## SERVICE BULLETIN

HEATING AND  
AIR CONDITIONING  
REFERENCE NUMBER 005  
DATE 01-08-88  
MODEL AE, EL, SV

### RECEIVER DRIER INLET/OUTLET TUBE BOLT TORQUE

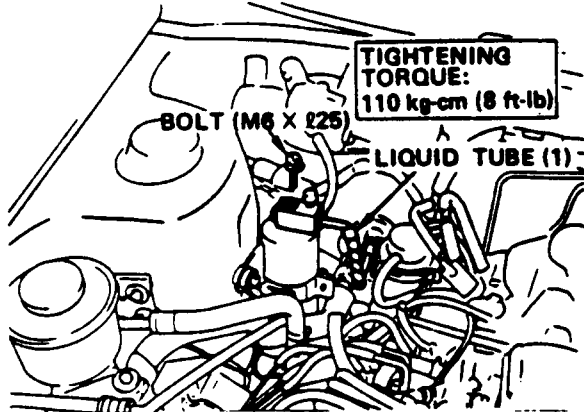
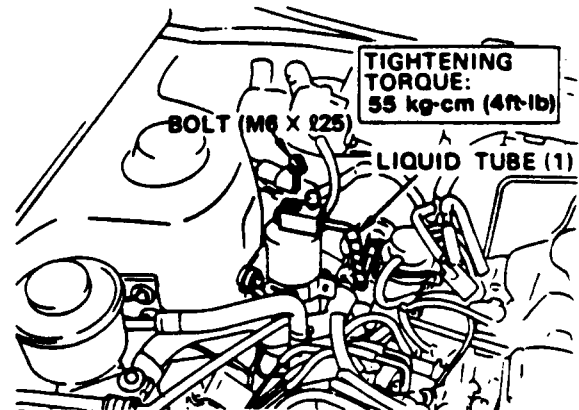
The torque specification for the inlet/outlet tube bolt for the receiver drier on Corolla, Tercel, and Camry in the 1988 Toyota Installation Manual CIAA-01 has been changed.

The installation Manual (CIAA-01) indicates the torque value for the inlet/outlet tube bolt should be 110 kg-cm (8 ft. lbs.). The torque value has been changed to 55 kg-cm (4 ft. lbs.) as follows:

Corrected Torque
